Comments to Certification Standard
Draft Release Date: May 26, 2006
Prepared by Microcom Design, Inc.

4.5 DCPRS Transmit Spectrum

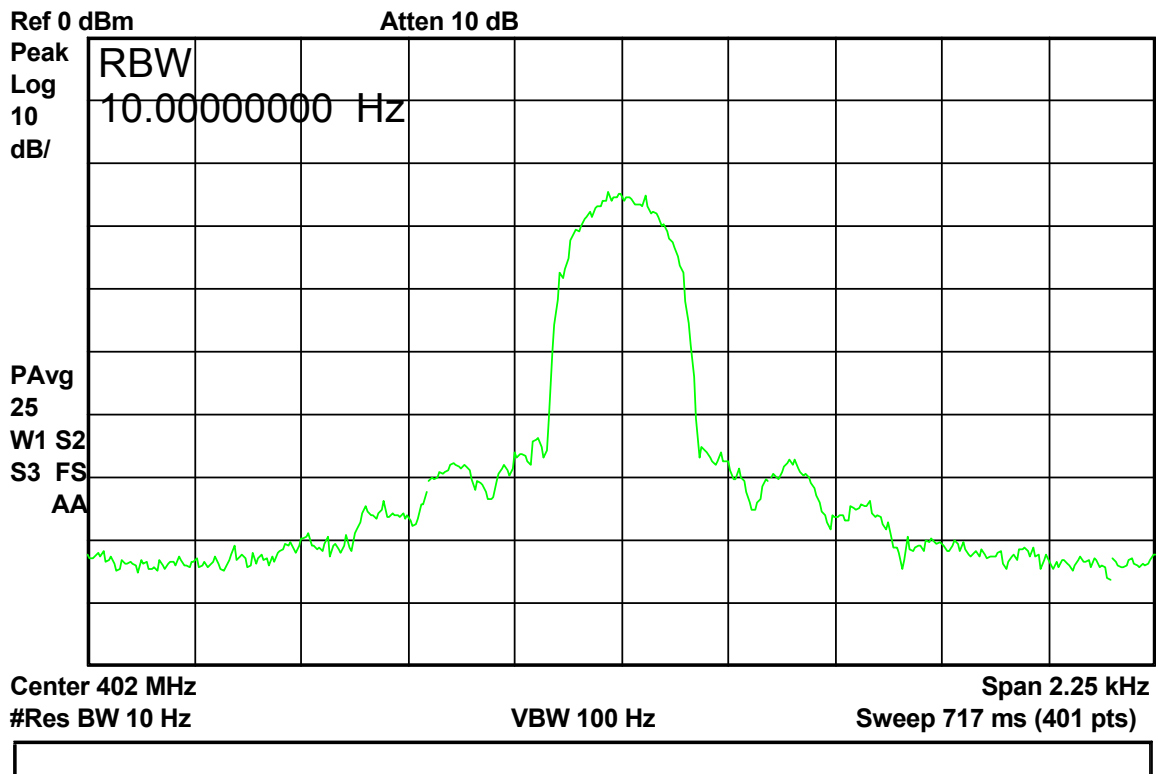
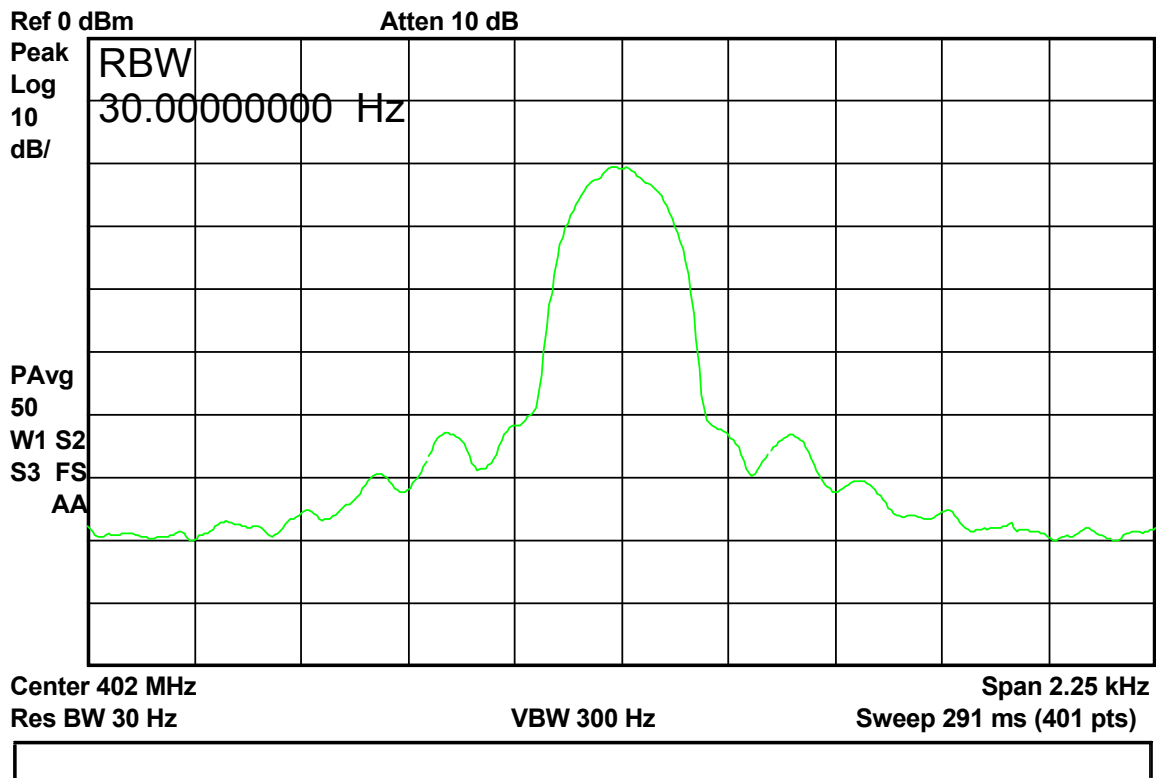
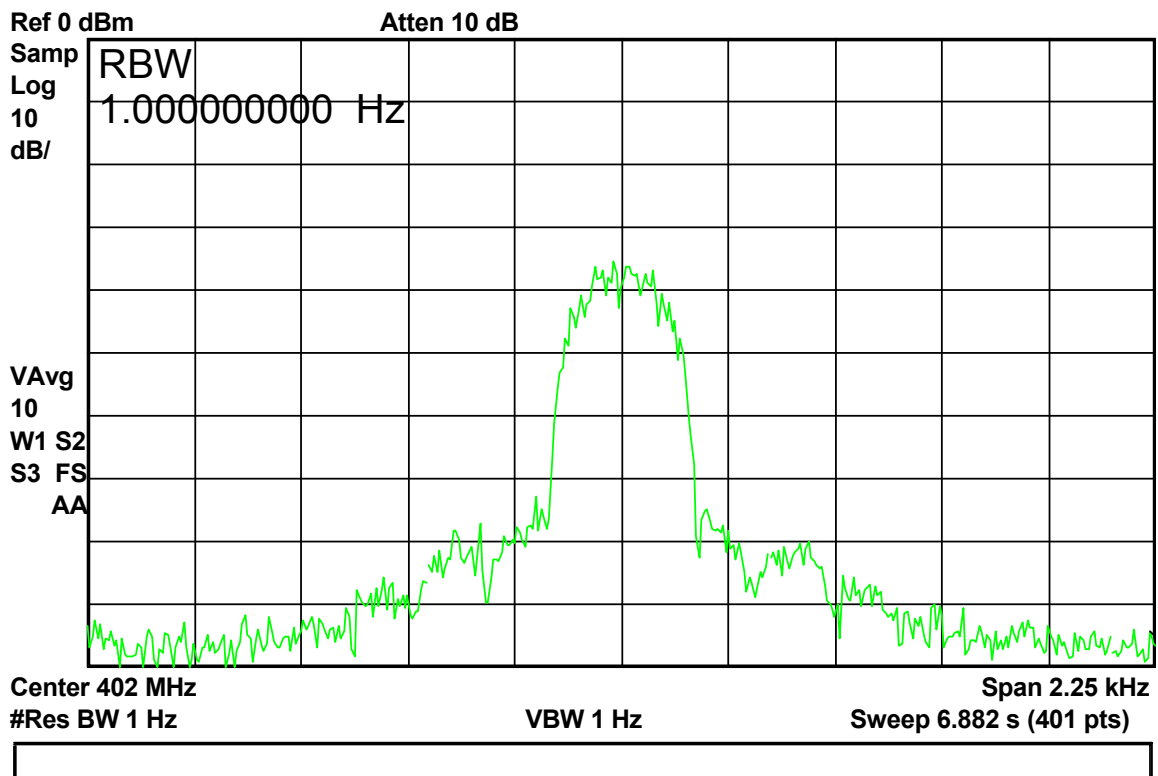
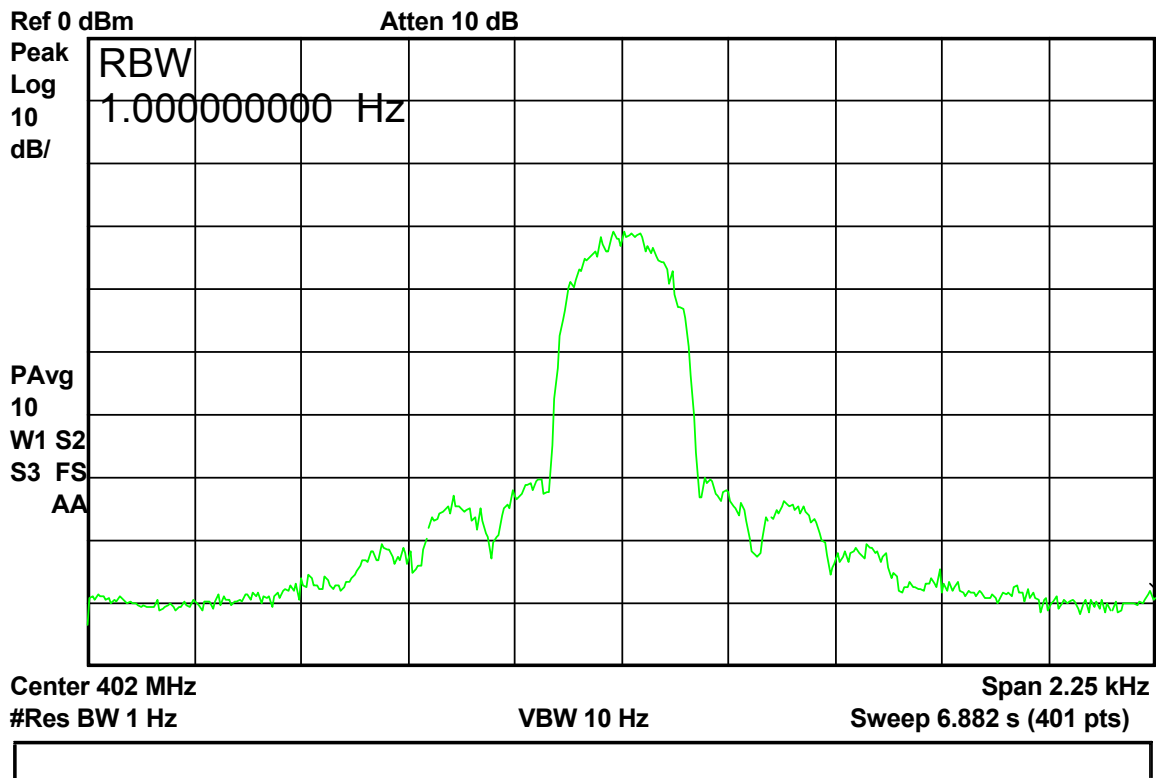
After running some tests Microcom believes that requiring a Resolution Bandwidth (RBW) of 1 Hz results in unreasonably long sweep times and is unnecessary. Provided below are four screen shots captured from Microcom's Agilent E4402B ESA-E Series Spectrum Analyzer (a fairly high-end and relatively new unit). Also provided below is a summary table detailing the effect of RBW on capture times.

As is clear from these data and the screen shots, the least smooth trace and the longest capture time occurred with an RBW and VBW of 1 Hz in Video Average Mode.

It should be noted that Agilent recommends using RMS Power averaging and a 10:1 VBW-to-RBW ratio for capturing signals such as these (see Agilent Application Note 1303). Further, the Agilent E4402B automatically selects 10:1 ratio when Power averaging is enabled and a 1:1 ratio when Video averaging is selected.

As is indicated in the table, when using a RBW of 1 Hz, the averaging count was reduced to only 10 sweeps so as to result in a capture time roughly equivalent to the fail-safe limit (i.e 110 seconds). Note that simply opening the RBW to 10 Hz allows the averaging count to be increased to 25 sweeps and still results in a complete capture taking a third to a fourth of the time. Beyond just speeding up the time to complete an individual capture, reducing the sweep time will significantly improves the overall test time since operating a transmitting for extended periods of time raises the temperature of the unit (due to self-heating). As such, extra time has to be expended to allow the unit to return to the ambient temperature before capturing the next run when each capture takes a long time.

In all the screen captures below, the span was set to 2,250 Hz (225 Hz per Div) so that the spectral mask steps align with the vertical grid. Actually capturing a valid spectral trace when the transmitter has to operate for 100 seconds or more can be problematic if the transmitter under test has a short term frequency drift close to the accepted limit of 1 Hz/sec. Such a transmitter would still be in spec (both short and long term) but would cause the spectral picture to shift by nearly $\frac{1}{2}$ a division; smearing the averaged trace.

As was noted previously, the above data was captured using a relatively new SA, and a 1 Hz RBW with a 2250 Hz span required ~ 6.9 seconds per sweep; the same setting on a useful but slightly older model SA (an HP 8560E) resulted in a sweep time of 9.0 seconds (a 30% increase).

All the times provided so far are for a transmitter being tested at 300 BPS. Applying the same 1 Hz RBW to 1200 BPS testing with the requisite factor of four increase in the span width increases the sweep time on the Agilent E4402B from 6.882 seconds to 20.65 seconds. The same change on the HP 8560E pushes the sweep time from 9.0 seconds to 34.2 seconds. Note that these are single sweep times (i.e. one pass across the screen) and do not account for the time to update the average trace; which must be significant as 10 averaged sweeps at 6.9 seconds per sweep took over 100 seconds not just 69-70 seconds.

Taking all this into account, Microcom recommends that the Resolution Bandwidth for 300 BPS be defined to be between 10 and 30 Hz, and the 1200 RBW be between 30 and 100 Hz. Further Microcom recommends that the VBW be specified to be consistent with the averaging mode used (Video vs. Power). Microcom reviewed the NTIA requirements and could not find any definitive requirement as to what RBW should be utilized. Section 1.1.3 of Annex M: Measurement Methods simply states ...
